SUBJECT: ISSUANCE OF AMENDMENT NO. 72 TO FACILITY OPERATING LICENSE
NO. DPR-18, R. E. GINNA NUCLEAR POWER PLANT (TAC NO. M95759)

AMENDMENT NO. 72 TO FACILITY OPERATING LICENSE NO. DPR-18-GINNA NUCLEAR
POWER PLANT

ATTACHMENT TO LICENSE AMENDMENT NO.72

SAFETY EVALUATION BY THE OFFICE OF NUCLEAR REACTOR REGULATION
RELATED TO AMENDMENT NO. 72TO FACILITY OPERATING LICENSE NO. DPR-18

Figure 3.7.13-1
Fuel Assembly Burnup Limits in Region 1

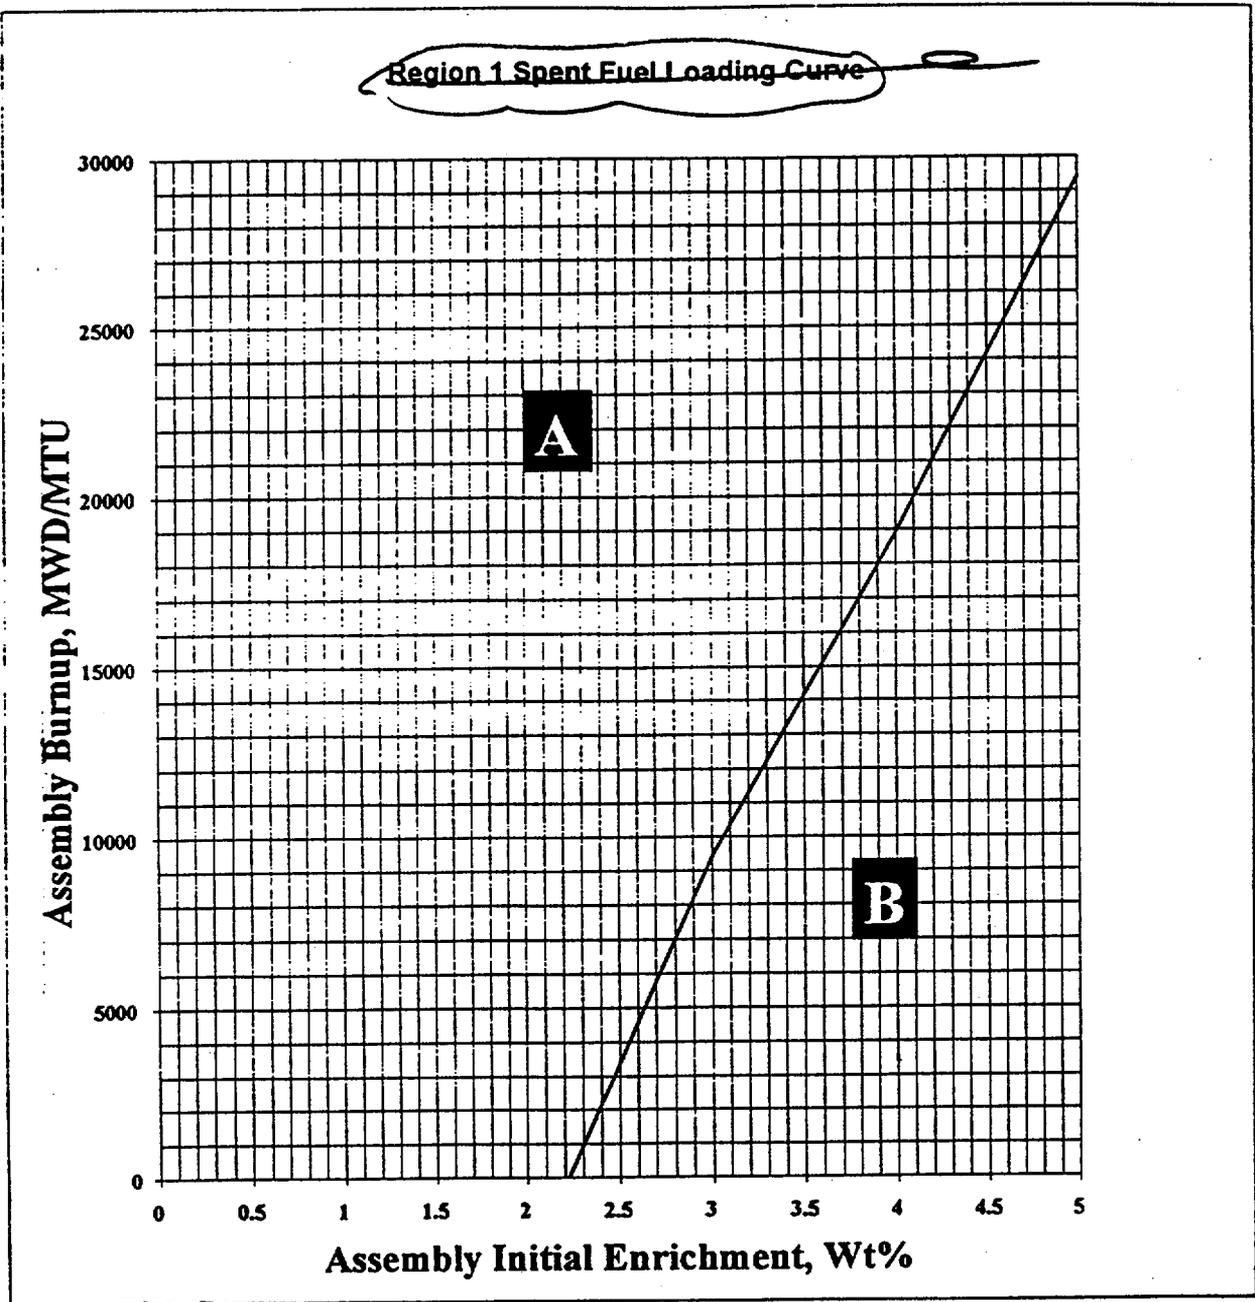
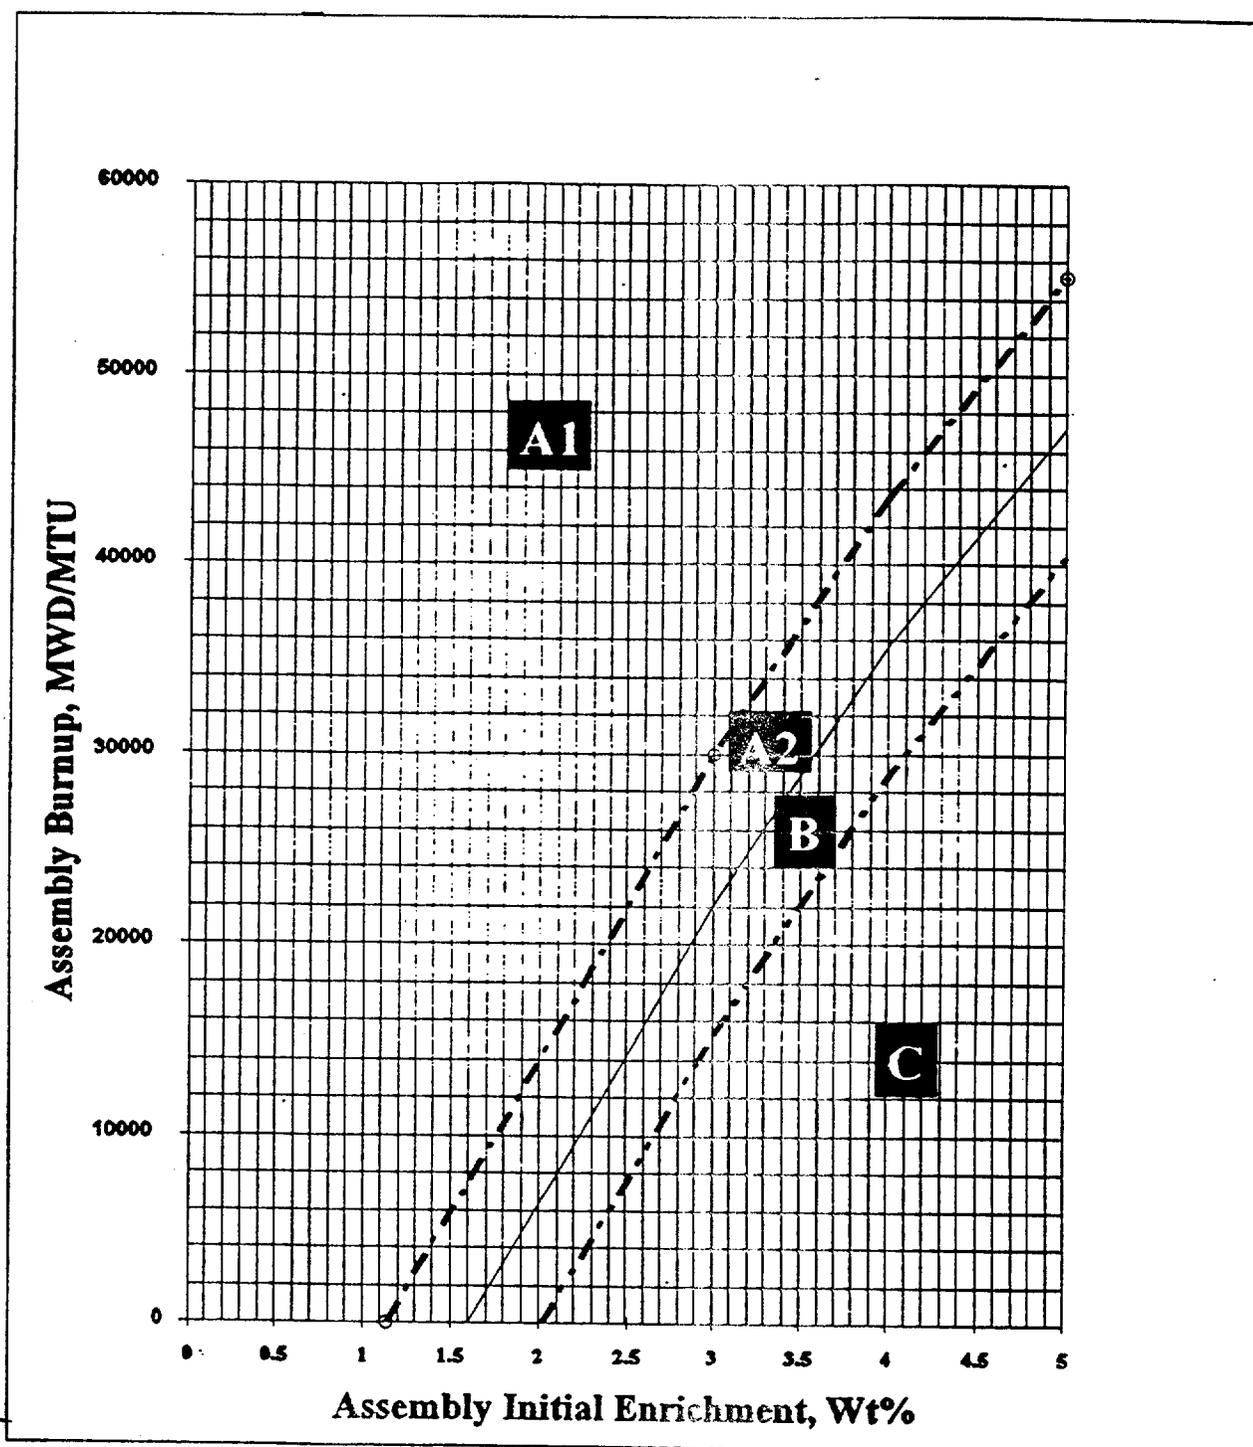
The concept of burnup reactivity equivalencing was used in order to store fuel with nominal enrichments up to 5.0 w/o U-235 in Region 1 checkerboarded with fresh 4.0 w/o U-235 (or up to 5.0 w/o U-235 with sufficient IFBAs). This concept is based on the reactivity decrease associated with fuel depletion and has been previously found acceptable by the NRC for use in pressurized-water reactor (PWR) fuel storage analysis. A series of reactivity calculations was performed to generate a set of enrichment versus burnup ordered pairs, which yields an equivalent k_{eff} for fuel stored in the Ginna racks. The results of the burnup reactivity equivalencing is shown in TS Figure 3.7.13-1 and shows that fuel with an initial U-235 enrichment of 5.0 w/o and irradiated to at least 29,400 MWD/MTU is equivalent to fresh fuel enriched to approximately 2.25 w/o U-235. Fuel with initial enrichment versus burnup values which meets the burnup requirements in Figure 3.7.13-1

(2) In TS 3.7.13, the requirements for storage in Region 1 would be revised to include restrictions on initial enrichment and accumulated burnup as identified in new Figure 3.7.13-1. The required action for not satisfying the storage requirements would be revised to allow movement of the noncomplying assembly to any acceptable storage location regardless of storage region. Figure 3.7.13-1 would be added to provide the initial enrichment and burnup restrictions for storage in specified locations in Region 1. Previous Figure 3.7.13-1 would be renumbered to 3.7.13-2 and revised to provide additional restrictions on acceptable storage locations for Region 2.

- (3) In SR 3.7.13.1, the Note providing an exemption to the SR when moving a fuel assembly from Region 2 to Region 1 would be removed. The additional restriction on initial enrichment and burnup given by Figure 3.7.13-1 would be added prior to storing a fuel assembly in Region 1.
- (4) TS 4.3.1.1 (b) would be changed to add a footnote stating that $k_{\text{eff}} \leq 0.95$ in the spent fuel storage racks would be maintained with a soluble boron concentration ≥ 2300 ppm until December 31, 1999.
- (5) TS 4.3.1.1 (c) would be changed to remove the statement concerning RGAF2 fuel storage canister not satisfying the requirements for initial enrichment and burnup of LCO 3.7.13.
- (6) In TS 4.3.3, the spent fuel pool storage capacity would be increased from 1016 to 1879 fuel assemblies and 1369 locations (assuming consolidation).

- a. Fuel assemblies in Region 1 shall have a K-infinity of ≤ 1.458 and shall have initial enrichment and burnup within the acceptable area of Figure 3.7.13-1; and
- b. Fuel assemblies in Region 2 shall have initial enrichment and burnup within the acceptable area of the Figure 3.7.13-2.
